Bulletin No:	B414R1220-0
Release Date:	July 30, 1999
Effective Date:	July 30, 1999
Supersedes:	N/A
Completion Date:	August 30, 1999
Page:	1 of 4

SERVICE BULLETIN

Ride Manufacturer:	CHANCE RIDES, INC.	Affected Production Dates:	All
Ride Name:	INVERTER (Portable Model) INVERTER (Park Model) DOUBLE INVERTER	Affected Serial Nos.:	All units
Model No.:	414

Abstract of Issue:
Vehicle Software Changes

Installation Instructions - Vehicle Software

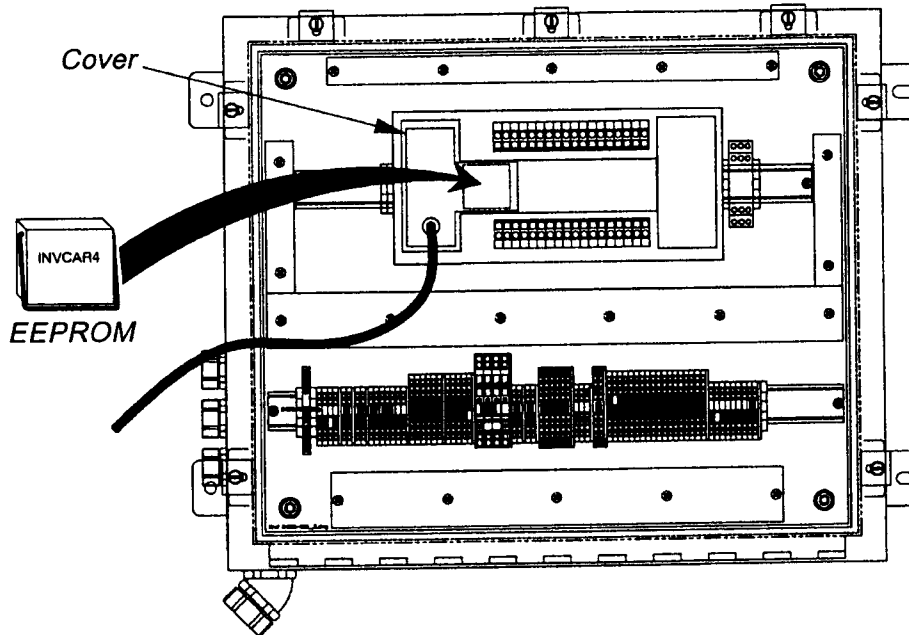
Chance Rides, Inc. has developed an EEPROM programmed with the new software. All owner/operators of the above noted INVERTER amusement rides are required to replace any previous version (labeled INVCAR3) with the new EEPROM (labeled INVCAR4). Order the new EEPROM (part number 32516314) and install it using the instructions in this bulletin. For DOUBLE INVERTER rides, order two EEPROM's.

1. Turn off the power to the ride.
2. Open the control enclosure on the rear of the vehicle and locate the PLC. Remove the EEPROM cover from the PLC and remove the EEPROM by pulling up on the metal bail wire under the EEPROM.
3. Install the new EEPROM in reverse order of the above steps.
